MILITARY SPECIFICATION

CANISTER, M11

This amendment forms a part of MIL-C-10116C(EA), dated 31 January 1980, and is approved for use within the Chemical Research, Development and Engineering Center, Department of the Army and is available for use by all Departments and Agencies of the Department of Defense.

FIGURE 1. Sifter fill apparatus front view (air entry ports removed)

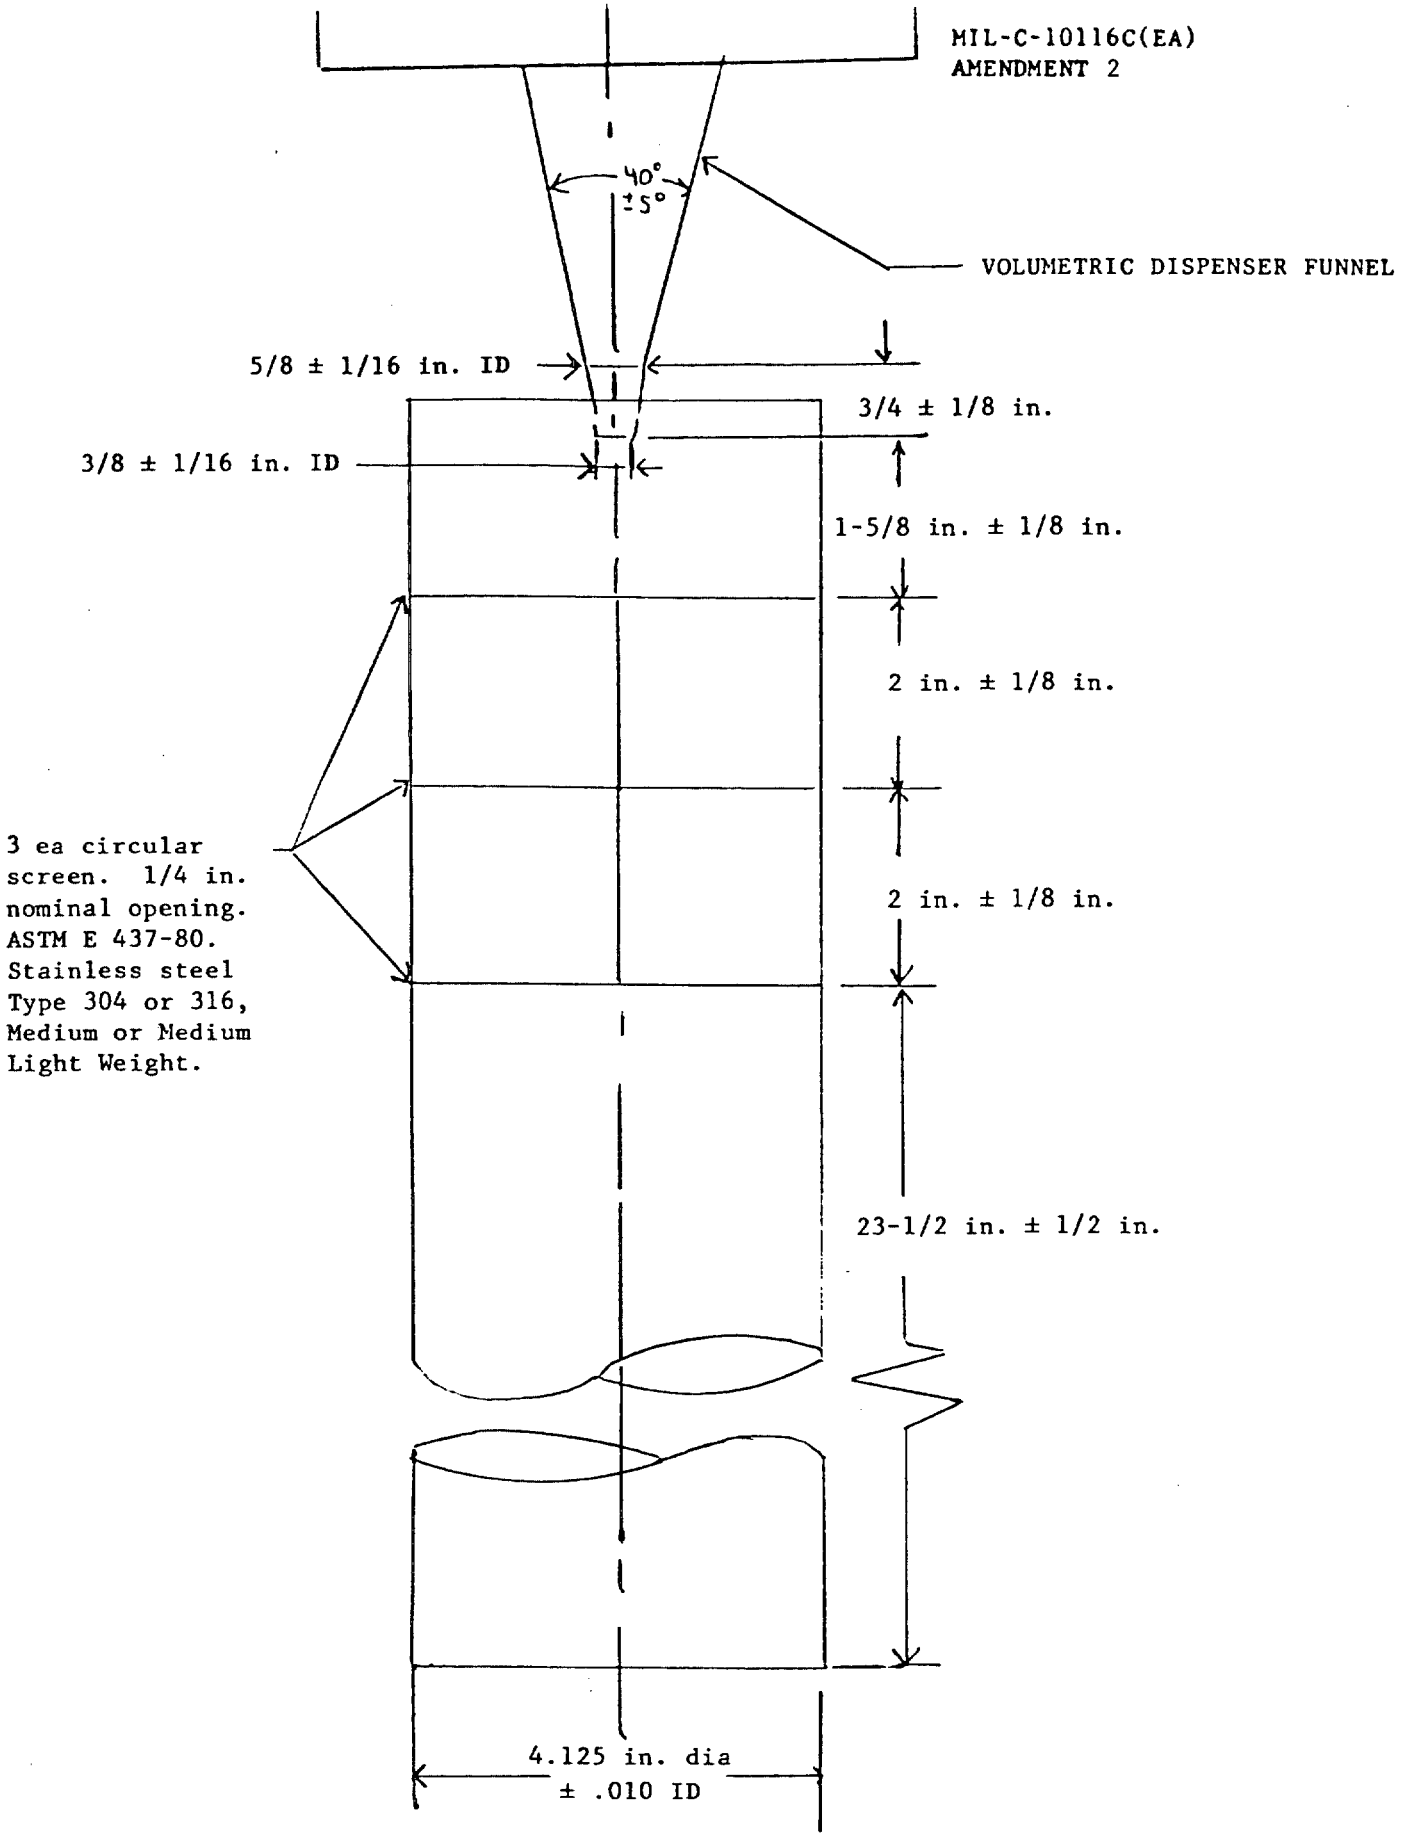
"Charcoal shall be loaded into the M11 Canister by the sifter fill (snowfall) method as depicted in figure 1. During loading, a constant average air flow velocity of 40 $\pm$ 2 cm/sec updraft shall be maintained through the entire length of the sifter fill drop tube. Three circular screens shall be placed as shown in figure 1, with no gaps between screen edge and tube wall. Each screen shall be rotated so that mesh orientation is 30° $\pm$ 5° from the next screen.

FIGURE 2. Air inlet hole pattern

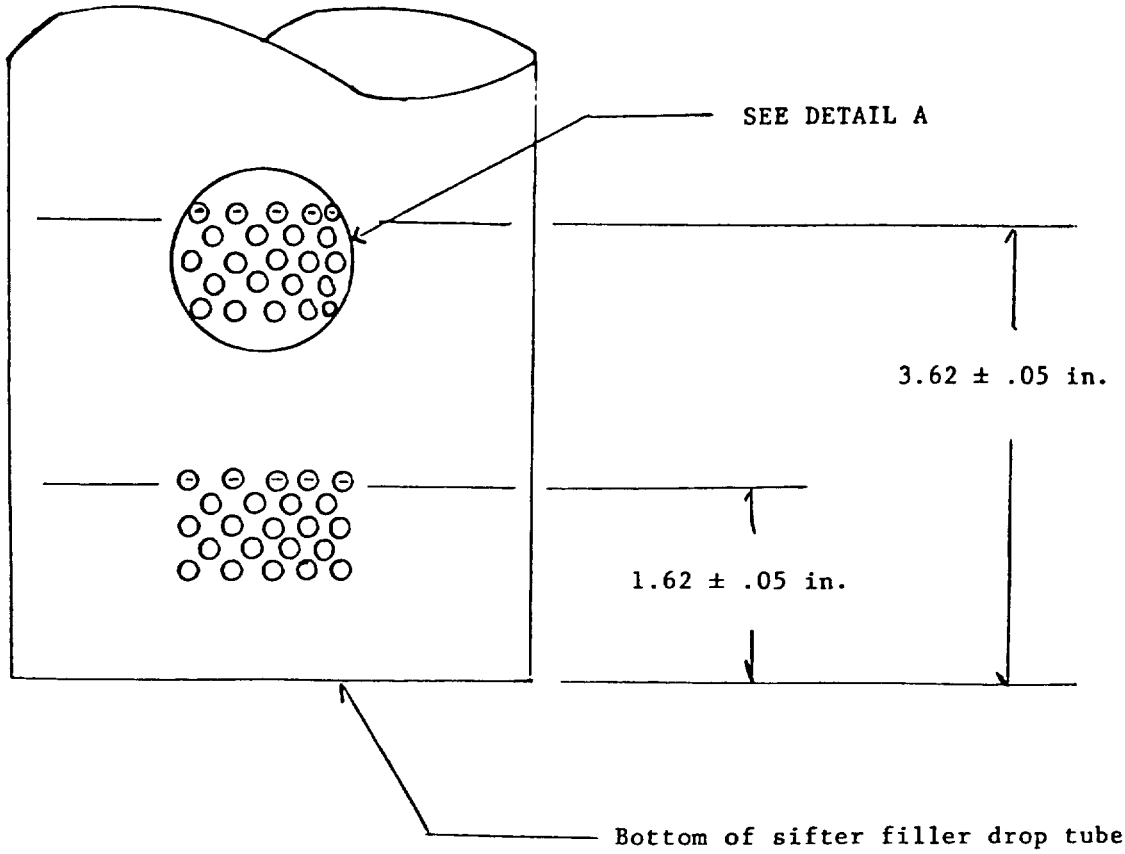
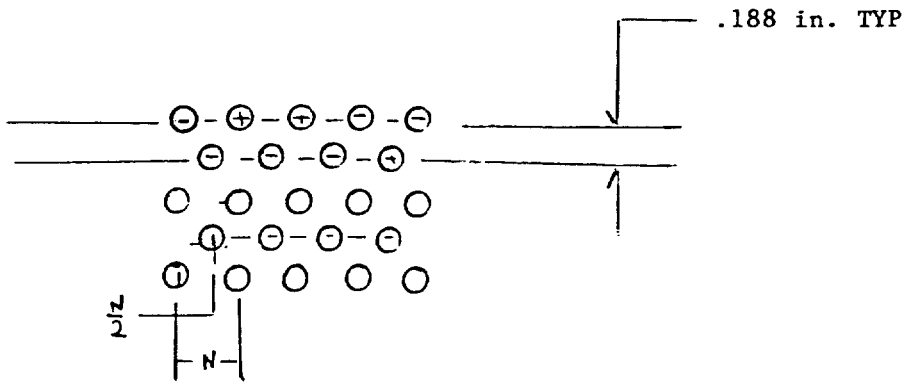
Air entering the bottom of the sifter filler drop tube shall be evenly distributed around the diameter of the tube by the hole pattern such as depicted by figure 2. Air entry holes shall be located a minimum of .75 inch from bottom outside edge of sifter fill tube. Interface between bottom of fill tube and canister shall be designed to minimize airflow between them (i.e., telescoping or flexible collar). Air exiting the sifter fill drop tube shall be permitted an increase in velocity only after it has passed the entrance area for the falling charcoal. Two acceptable methods are shown in figures 3 & 4."

EACH ROW SHALL CONSIST OF 36 HOLES OF .125 +/- .010 IN. DIA EQUALLY SPACED AROUND THE PERIPHERY, FIVE ROWS TOTAL, TWO PLACES, AS SHOWN
